## **SELLERS FAMILY ESTATES SUBDIVISION**

APPLICATION NUMBER 13 DATE June 18, 2009

REQUEST Subdivision

# DETAIL SITE PLAN

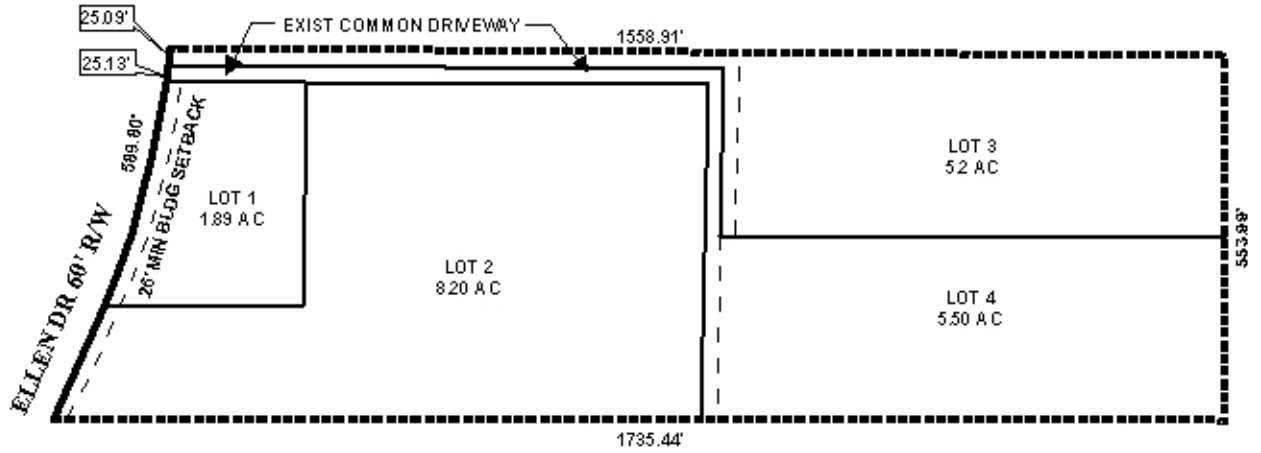
Lot 2 would exceed the depth-to-width ratio of Section V.D.3. of the Subdivision Regulations; however, narrow, deep lots are typical of the area, so a waiver of that section would be in order. Also Lots 3 and 4 would be “flag” lots which are generally not allowed by the Subdivision Regulations. However, exceptions are allowed in instances where varied and irregularly-shaped lot designs are common and the informality of design is consistent with other lots in the vicinity, or in the case of a family subdivision. “Flag” lots are typical of the area and this is a family subdivision; therefore, a waiver of Section V.D.1. of the Subdivision Regulations would be in order. A note should be added to the final plat stating that there shall be no future resubdivision of Lot 3 and 4 to create additional lots unless a County standard street is to be dedicated and constructed to provide access.

The site fronts on Ellen Drive with a compliant 60' right-of-way; therefore, no dedication would be required. A note should be required on the final plat stating that Lot 1 is limited to two curb cuts to Ellen Drive, and Lots 2, 3 and 4 are limited to one curb cut each onto Ellen Drive, with the size, location and design of all curb cuts to be approved by County Engineering and conform to AASHTO standards. As on the preliminary plat, the building setback line for Lots 1 and 2 should be illustrated as measured from the Ellen Drive right-of-way, and as measured from the Lot 4 “pole” for Lot 3, and from the rear line of Lot 2 for Lot 4. As on the preliminary plat, each lot should be labeled with its size in acres, or a table should be furnished on the final plat providing the same information.

- 1) placement of a note on the final plat stating that Lot 1 is limited to two curb cuts to Ellen Drive, and Lots 2, 3 and 4 are limited to one curb cut each onto Ellen Drive, with the size, location and design of all curb cuts to be approved by County Engineering and conform to AASHTO standards;
- 2) illustration of the building setback line for Lots 1 and 2 as measured from the Ellen Drive right-of-way, and as measured from the Lot 4 “pole” for Lot 3, and from the rear line of Lot 2 for Lot 4;
- 3) labeling of each lot with its size in acres, or the furnishing of a table on the final plat providing the same information;

- 4) placement of a note on the final plat stating that development of the subdivision shall comply with the Environmental and Watershed Protection requirements of Section V.A.5. of the Subdivision Regulations;
- 5) placement of a note on the final plat stating that development of the site must be undertaken in compliance with all local, state and Federal regulations regarding endangered, threatened or otherwise protected species;
- 6) placement of a note on the final plat stating that any lots which are developed commercially and adjoin residentially developed property must provided a buffer, in compliance with Section V.A.7 of the Subdivision Regulations; and
- 7) placement of a note on the final plat stating that that there shall be no future resubdivision of Lots 3 and 4 to create additional lots unless a County standard street is to be dedicated and constructed to provide access.
